METROPOLITAN GOVERNMENT OF NASHVILLE AND DAVIDSON COUNTY

STAFF RECOMMENDATION 1005 Paris Avenue September 19, 2018

Application: New Construction—Addition and Outbuilding; Setback Determination; Partial Demolition

Applicant: Kaitlyn Smous, Nine12 Architects

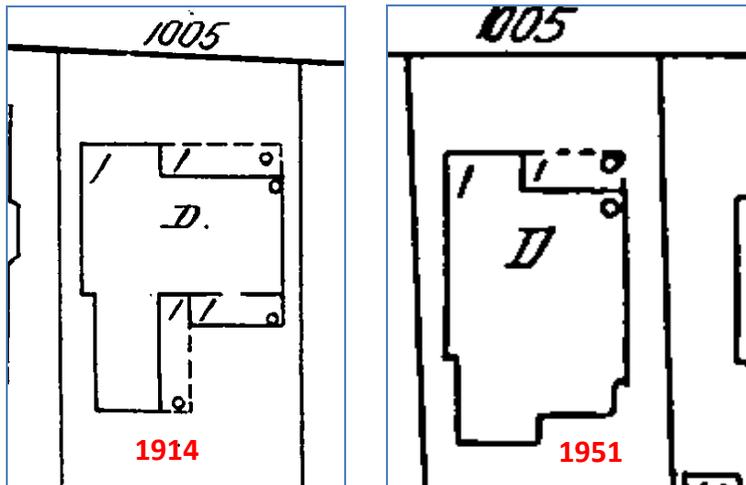
Partial Demolition: The applicant proposes to remove non-contributing portions of the existing house at the rear (Figures 2 & 3).

Figure 2 (left) is an aerial view of the roof. The blue portion is the historic roof form. The red portion is what is non-contributing and proposed to be removed. Figure 3 (right) is a photo of the rear façade, showing the area of demolition.

Parts of the area to be removed may have been part of the original structure, as the 1914 Sanborn Map shows parts of these areas as porches (Figure 4). At some point between 1914 and 1951, the porches were fully enclosed and the addition was extended out to the rear (Figure 5). Staff finds that these low-sloped areas of the house are not architecturally significant and that their removal will not alter the historic character of the house or its roof form.

Staff finds that the proposed partial demolition meets Section V.B.2 for appropriate demolition and does not meet section V.B.1 for inappropriate demolition.

SITE PLAN

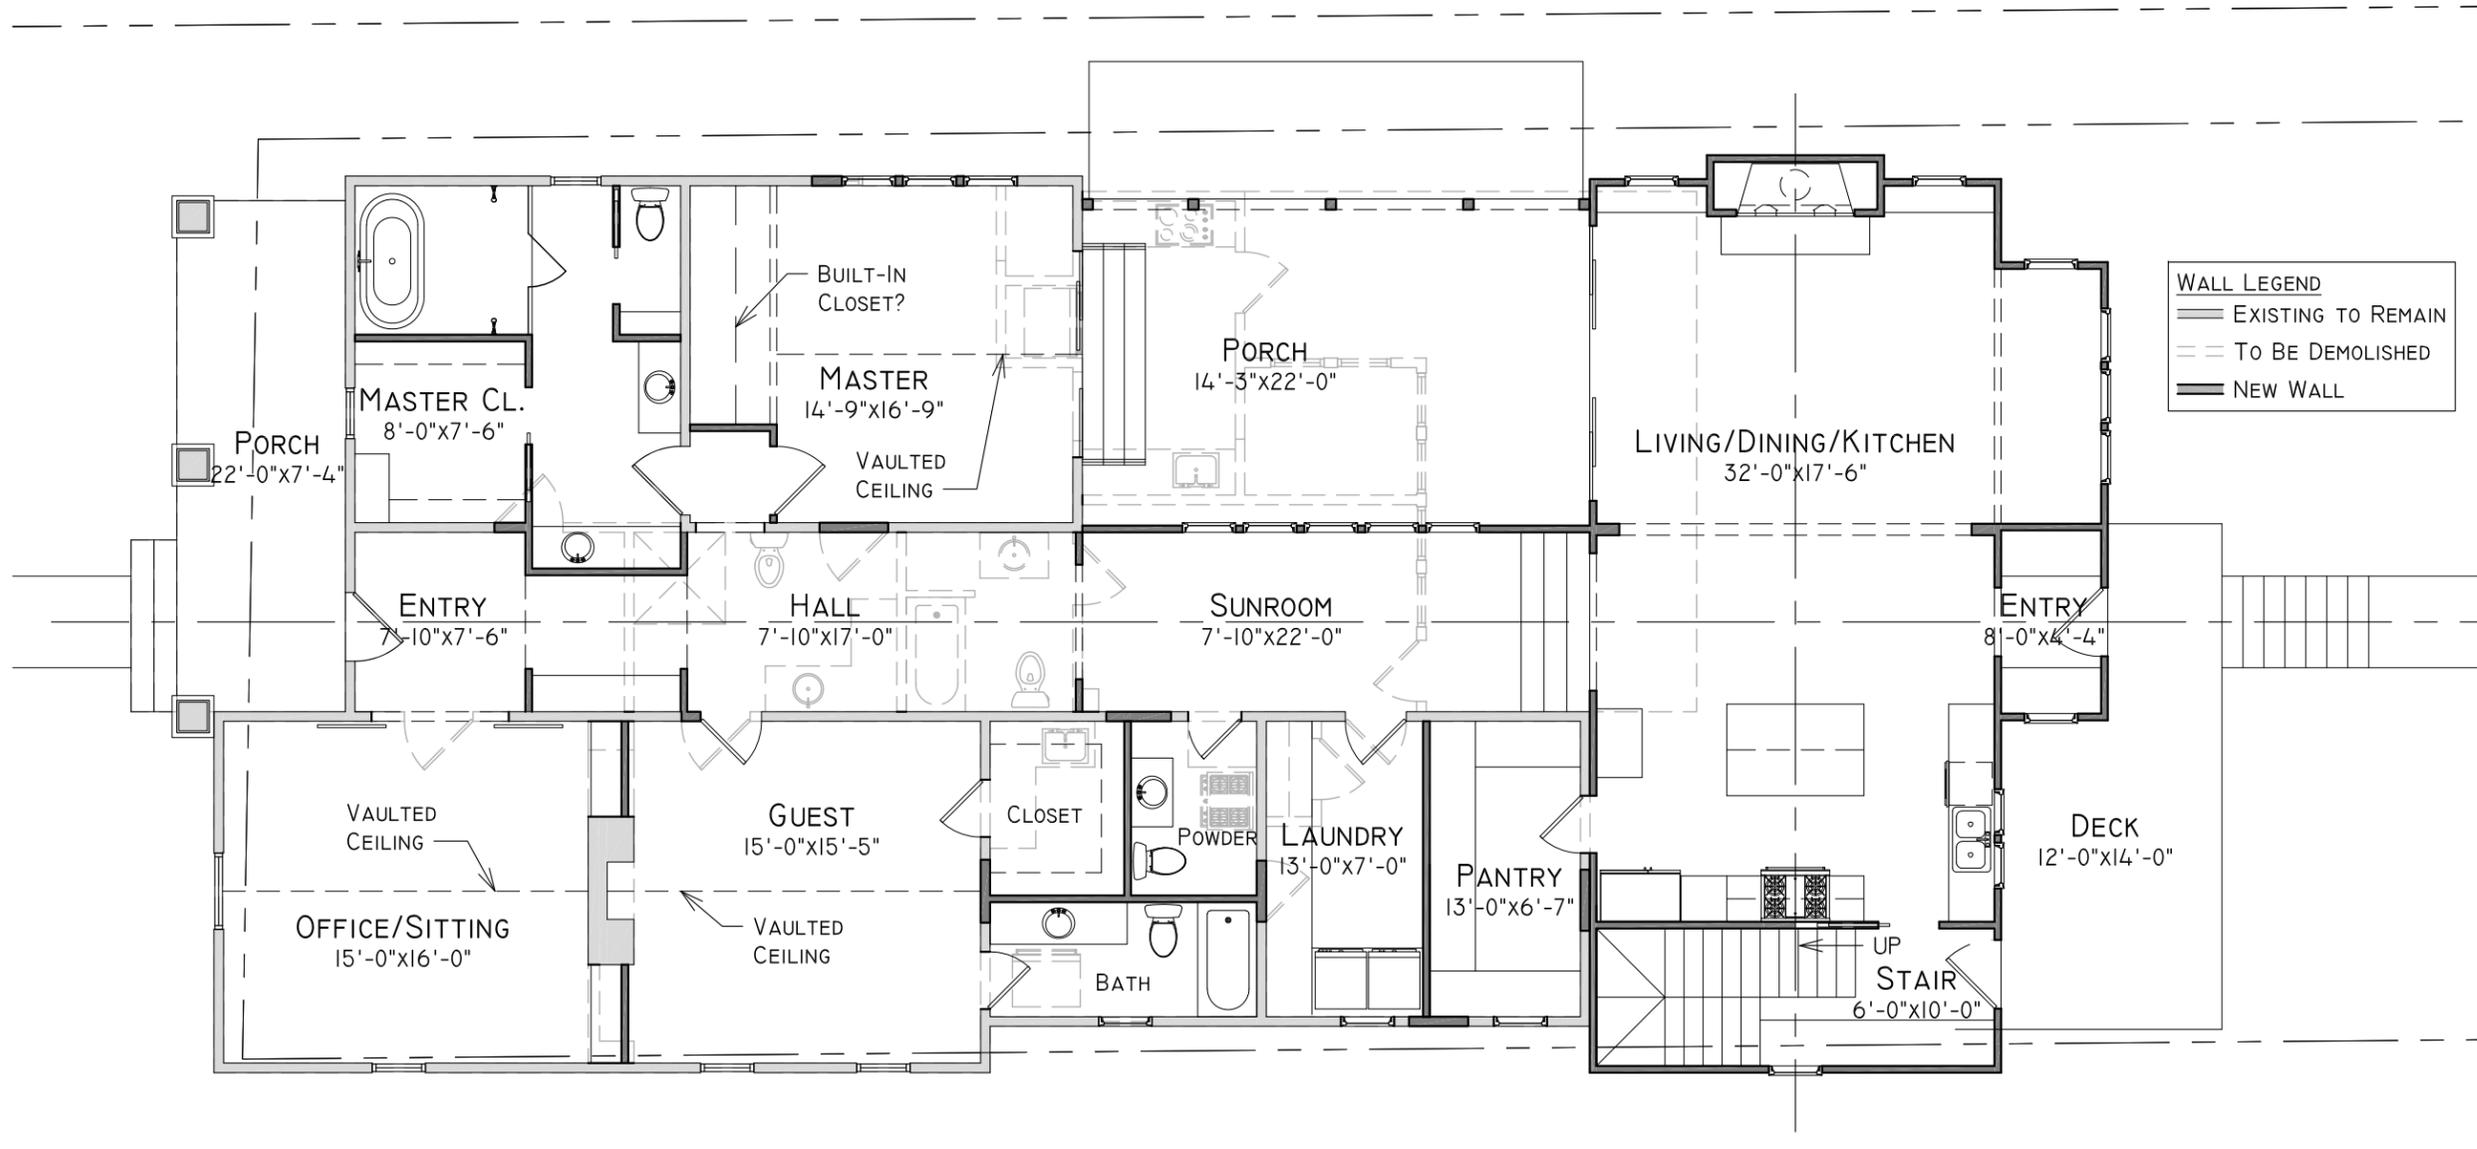
Setback & Rhythm of Spacing: The addition meets the base zoning setbacks on the left/east and rear, but requires a setback determination on the right/west side. On the left/east side, the addition is seven feet, four inches (7'4") from the side property line; the addition will be approximately forty-seven feet (47') from the rear property line. On the right/west side property line, base zoning requires a five foot (5') side setback, but the applicant is proposing a setback of three feet, nine inches (3'9"). The existing house is shifted on the lot so that it is four feet, one inch (4'1") from the right/west side property line. The house is also angled slightly on the lot so that the addition will be two inches (2") closer to the property line than the historic house, even though the addition is no wider than the historic house. Staff finds the proposed side setback of three feet, nine inches (3'9") to be appropriate because the addition will not be any wider than the historic house and because historically, it was not uncommon for houses to sit closer than five feet (5') from the side property lines. Staff therefore finds that the proposed setbacks meet Section III.C. and IV. of the design guidelines.

ELEVATIONS

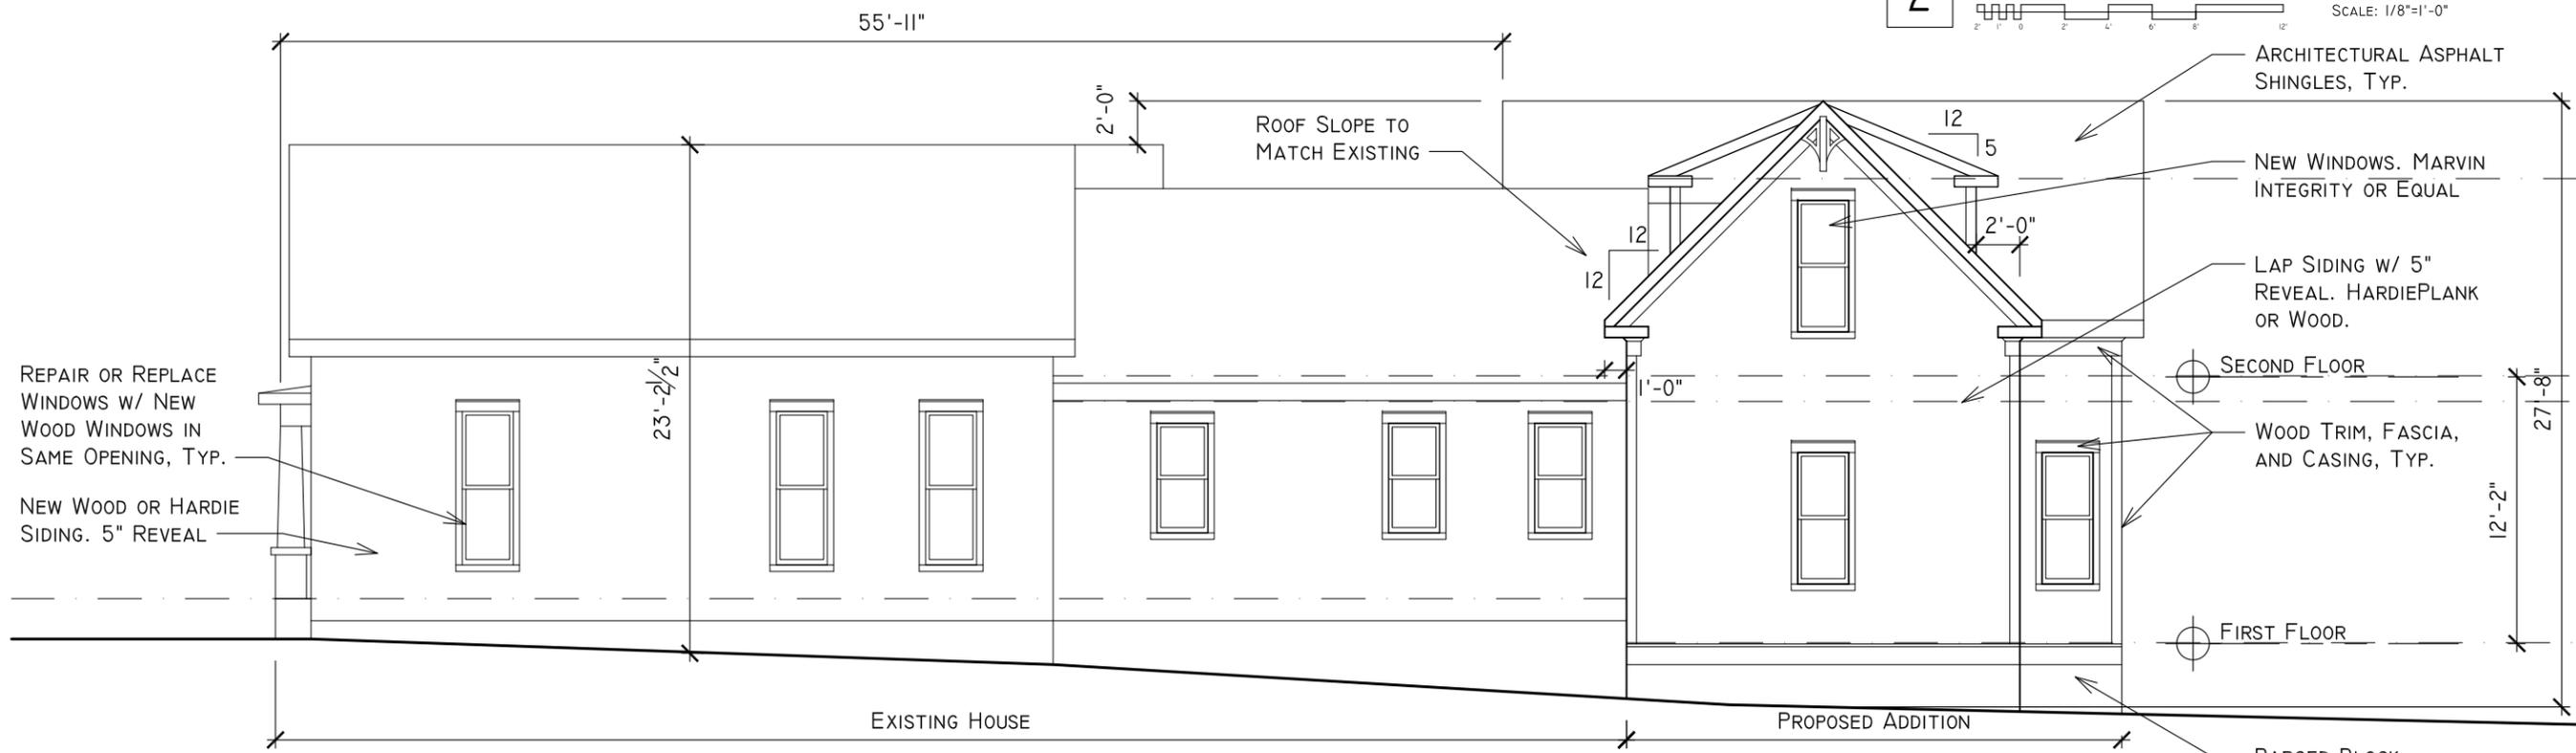
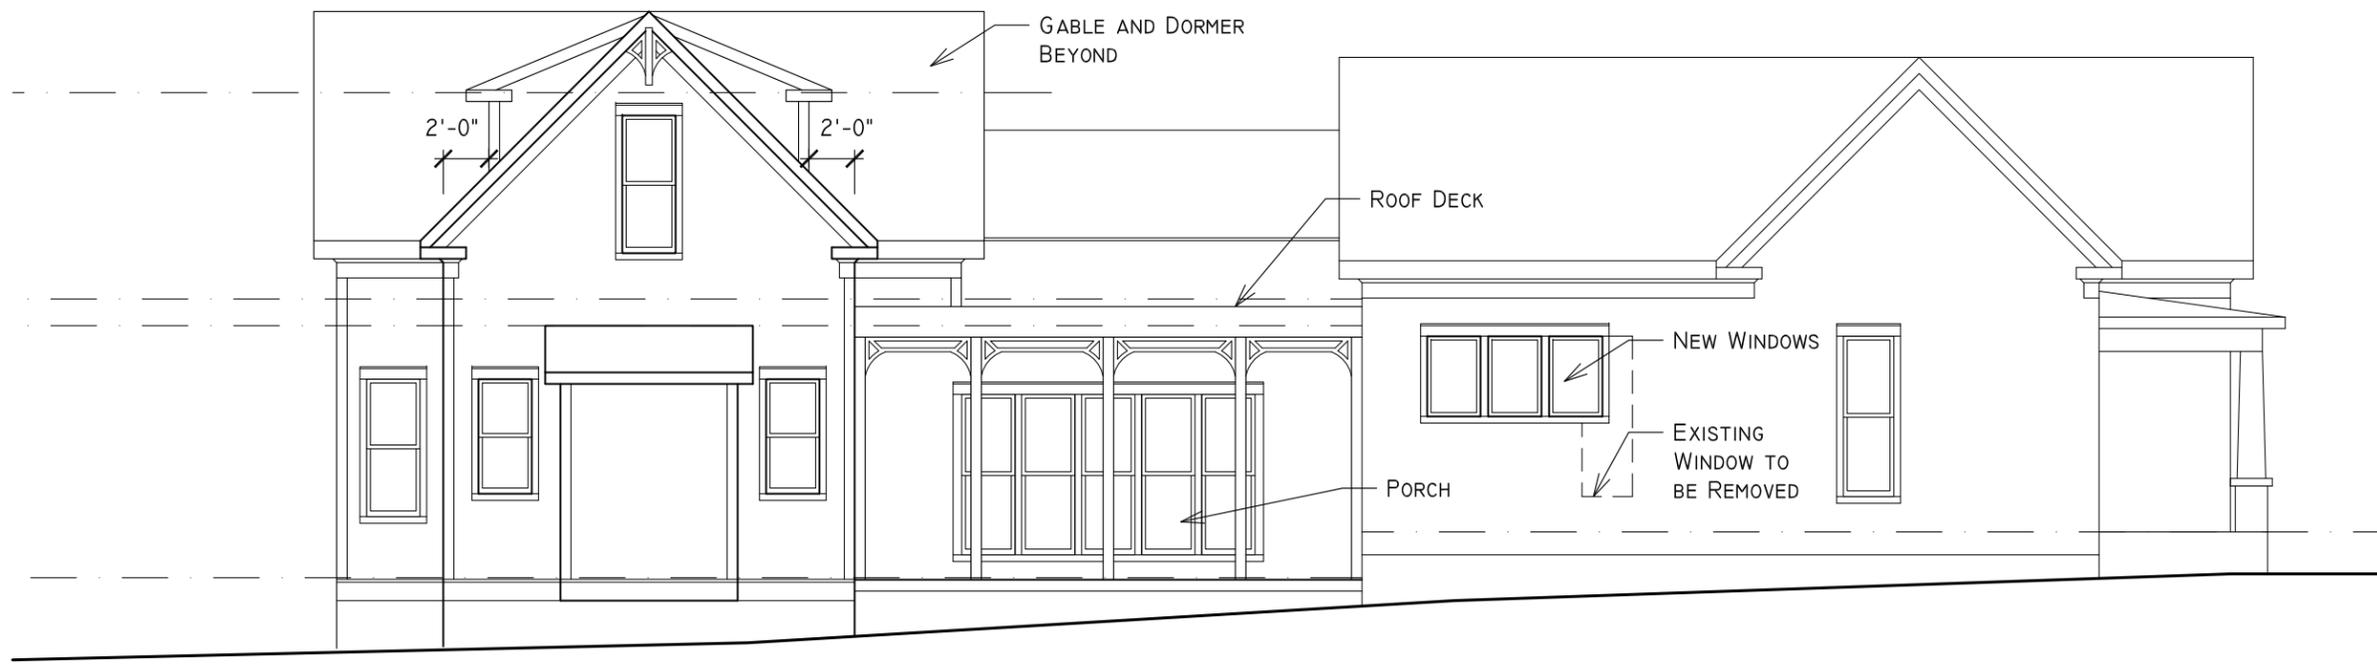
Height & Scale: The proposed rear addition will be a one-and-a-half story addition behind a two story house. It will not be any wider than the historic house, but will be taller. The addition will be a maximum of two feet (2') taller than the historic house, which staff finds to be appropriate because the extra height does not occur until approximately fifty-six (56') back from the front of the house. On the left side, the addition is inset one foot (1'). Although staff typically recommends a two foot (2') inset for additions of this size, staff finds the one-foot inset to be appropriate for a couple of reasons. First, this part of the addition will replace the existing one-story addition that is just inset one foot (1'). In other words, this part of the addition will have the same inset as the existing addition that is to be removed. Second, this part of the addition is a one-story porch which will be open in nature, and the solid wall for the addition is pushed back about fifteen feet (15').

On the right side, the addition will attach to a portion of the historic house that is inset two feet (2') from the main form of the house. The applicant there is proposing not to inset the addition further, but to differentiate it by stepping it out to line up with the main wall of the house. Staff finds this to be appropriate in this instance because of the peculiarities of the house's various roof forms and sections.

Design: The addition's change in materials, inset on the left side, and separate roof form help to distinguish it from the historic house and read as an addition to the house. At the same time, its scale, materials, roof form, and fenestration pattern are all compatible with the historic character of the existing house. Staff finds that the proposed addition meets Sections IV.B, IV.E, and IV.G of the design guidelines.

portion of the addition is just one story in height. This flat portion will have a roof deck. The taller portion of the addition will be cross gabled with at 12/12 slope. It includes shed dormers that are inset two feet (2') from the wall below.

The design guidelines state that additions that are taller than the historic structure should have a side gabled, clipped gable, or hipped roof form. The front facing gable of the taller portion of the addition will not be clipped. Staff, however, finds this roof form to be appropriate because the part of the roof that has a front-facing gable and extends taller than the historic house is just four feet (4') wide, two feet (2') tall, and is located approximately fifty-six feet (56') back from the historic house. It will not likely be highly visible from the street.

Staff finds that the proposed addition meets Section III.A. III.B., and IV. B. of the design guidelines.

Staff finds that the proposed roof forms meet Sections III.E. and IV.C of the design guidelines.

OUTBUILDING ELEVATIONS
A2.2

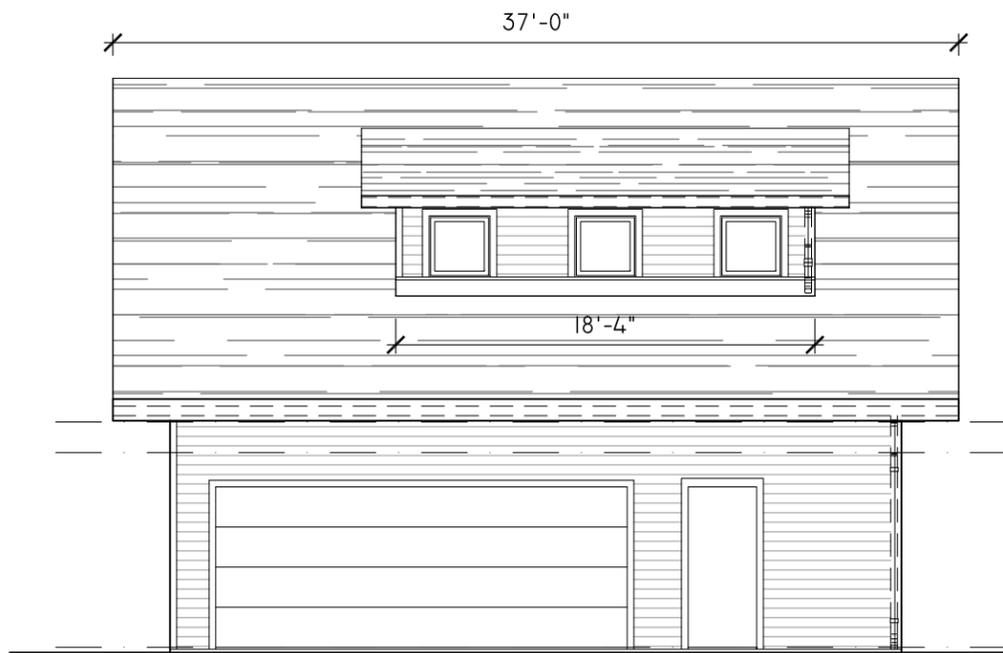
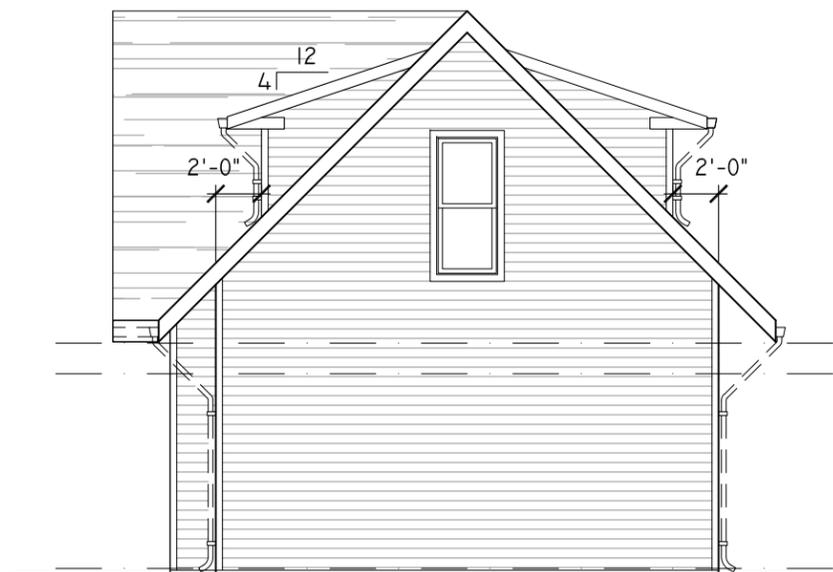
The outbuilding has a simple design that is appropriate for outbuildings. Its roof form, detailing, and form do not contrast greatly with the primary structure. The windows, dormers, height, scale, and materials are all appropriate for the site and the historic neighborhood. The proposed design of the outbuilding does not contrast greatly with the surrounding historic buildings and therefore meets the design guidelines.

With staff's final approval of the roof color and all windows and doors, staff finds that the known materials meet the design guidelines.

Staff finds that the outbuilding's location, height, scale, roof form, dormers, setbacks, and materials meet Sections II.B.i. of the design guidelines.
